TECHNICAL NOTE

Filing Code 1525 (P-401)
Date Issued December 1969

Bureau of Land Management U.S. DEPARTMENT OF THE INTERIOR

FORD TRUCKS

Figure 1

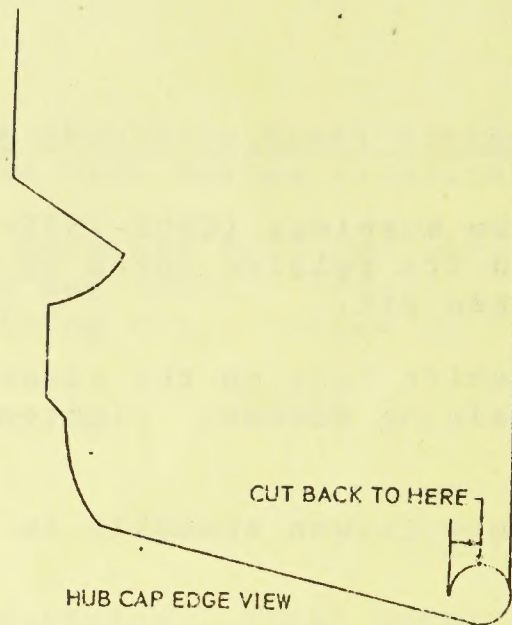
VI. Hub Cap Retention. (F&P250/350-1968-69)

To improve retention remove hub caps and grind the rolled inner edge of the cap at two opposite spots to match the two retaining bosses on the wheel. Remove metal from the inner rolled edge to a point approximately one-third of the total edge. Refer to Figure 1.

Figure 2

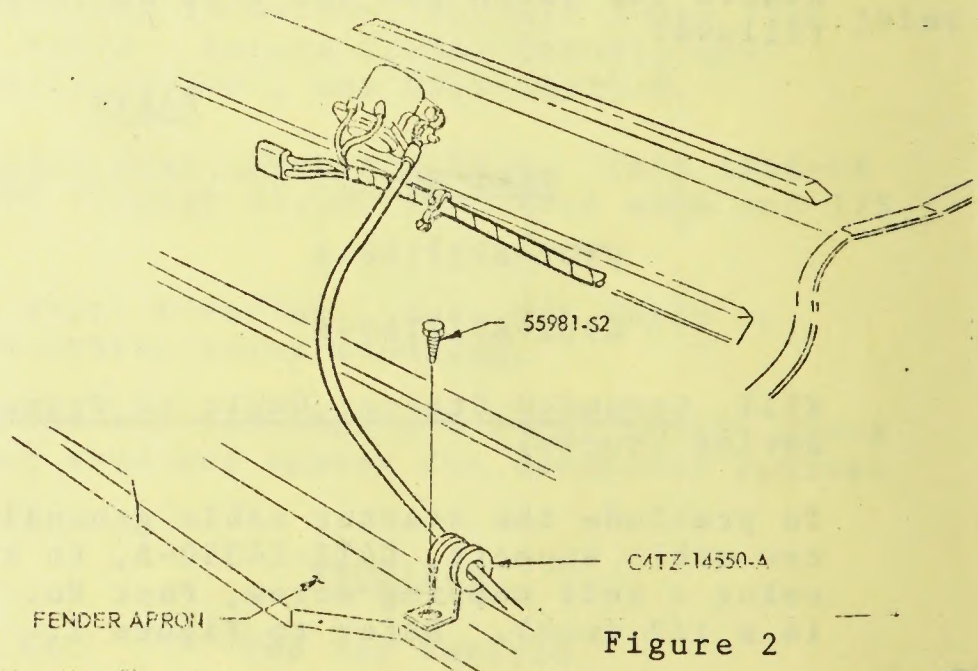
XIII. Grounded Starter Cable to Frame. (1968 - 69 F&B 500-750 Series Trucks)

To preclude the starter cable grounding on the frame, mount a new cable support, C4TZ-14550-A, to the right hand fender apron using a self tapping screw, Part No. 55981-S2 (1/4 inch - 14 x 1/2 inch). Refer to Figure 2.
